Addendum for LR30 & LR31 Series

LR30 & LR31 SERIES SENSOR TO LR98 DISPLAY

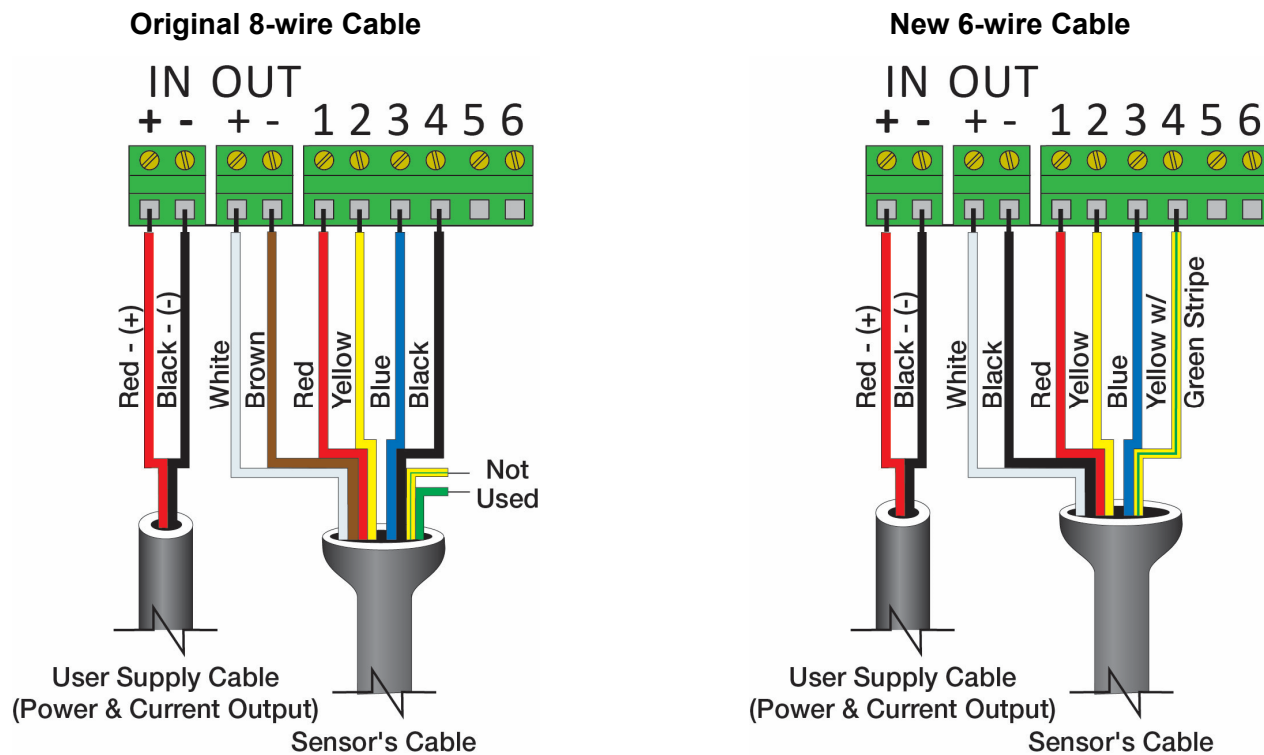
The LR98 display is used with the LR30 or LR31 sensor for configuration of the sensor. The Cable has changed from an 8-wire cable to a 6-wire cable. Please review the wiring changes below.

Once the EchoPulse LR30 or EchoPro LR31 has been configured, you can bypass the LR98 and wire the White and Black wires directly to any device that accepts a 4-20mA signal. The example below shows the LR30 wired to a multimeter set to read the 4-20mA current output of the sensor.
